**PLANNED UNIT DEVELOPMENT
& SUBDIVISION STAFF REPORT****Date: December 21, 2006****DEVELOPMENT NAME**

Brandonwood Subdivision

Subdivision and Planned Unit Development Approval to allow reduced lot widths and building setbacks in a zero-lot line, single-family residential subdivision.

SITE PLAN

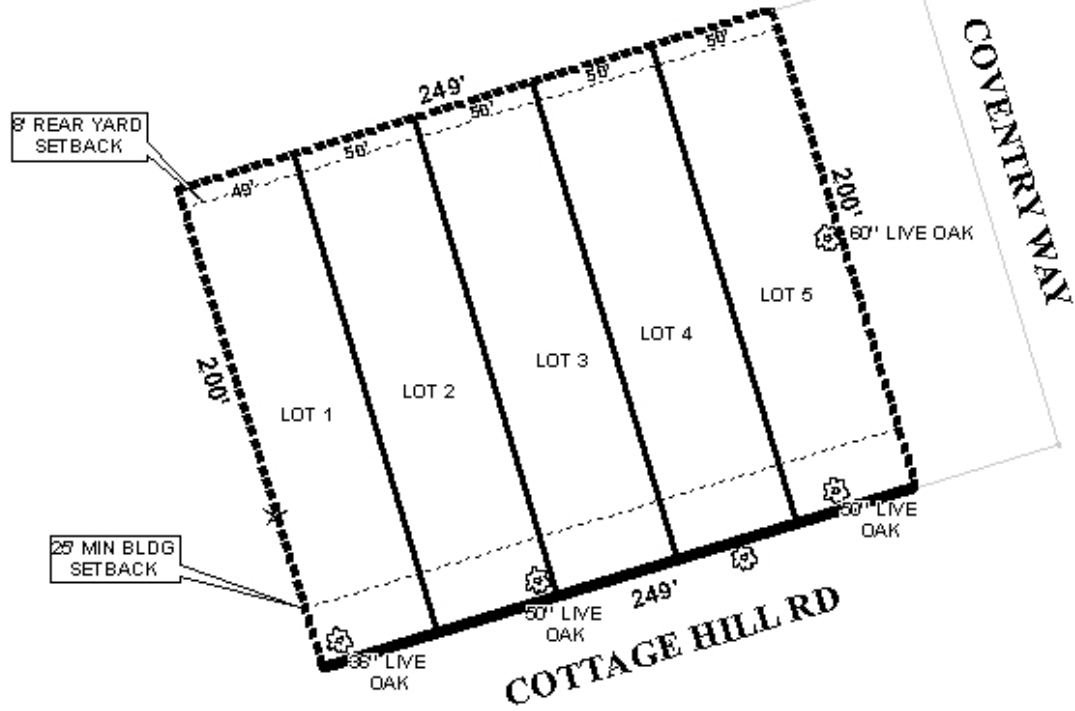
Preservation status is to be given to the Two 50" Live Oak Trees located on the South side of Lot 5 and Lot 2. Any work on or under these trees is to be permitted and coordinated with Urban Forestry; removal to be permitted only in the case of disease or impending danger.

60" Live Oak Tree located on the East side of Lot 5 was damaged by recent fire causing damage to half of the tree's canopy. Due to the damaged canopy, Urban Forestry is not requesting preservation for the 60" Live Oak Tree.

Section V.D. of the Subdivision Regulations require lots to be a minimum of 60-feet in width. The depth to width ratio is generally recommended to be 3.5 or less. With a proposed lot width of 50-feet, the depth to width ratio will be approximately 4.

The Zoning Ordinance requires the following setbacks in an R-1 district: front – 25 feet, side – 8 feet minimum, with 12 feet on the other side, and rear – 8 feet. Typically, reduced setbacks for a development are applied to internal lot lines, not to property lines that form the perimeter of the PUD. This application, as submitted, would result in zero and 8-foot side yard setbacks occurring adjacent to existing single-family homes.

As proposed, the PUD and Subdivision request appears to be incompatible with the majority of the development on Cottage Hill Road. Specifically, the property widths would be substantially less than surrounding properties and the requirements found in the Subdivision Regulations, the depth to width ratio would exceed that recommended in the Subdivision Regulations, and the side yard setbacks would be substantially less than found on surrounding properties.

Conceptually, the development depicted on the proposed site/layout plan does not minimize impacts to the surrounding residential development, especially with the proposed 0-foot building setback along the sides of the site. It should be noted, however, that there is no indication on the site plan regarding the proposed side yards of the property; specifically if the zero setback line is proposed adjacent to existing residential development.

Planned Unit Development: Based upon the preceding, this application is recommended for Denial for the following reasons: 1) the reduced side yard setbacks and reduced lot widths would be incompatible with the majority of the existing residential development on Cottage Hill Road; and 2) that there would be a 0-foot setback adjacent to property outside the Planned Unit Development (PUD).

Subdivision: Based upon the preceding, this application is recommended for Denial for the following reasons: 1) does not comply with the minimum required lot width specified in the Subdivision Regulations; 2) does not comply with the minimum setbacks as required by the Zoning Ordinance; and 3) does not comply with the depth to width ratio recommendation within the Subdivision Regulations.
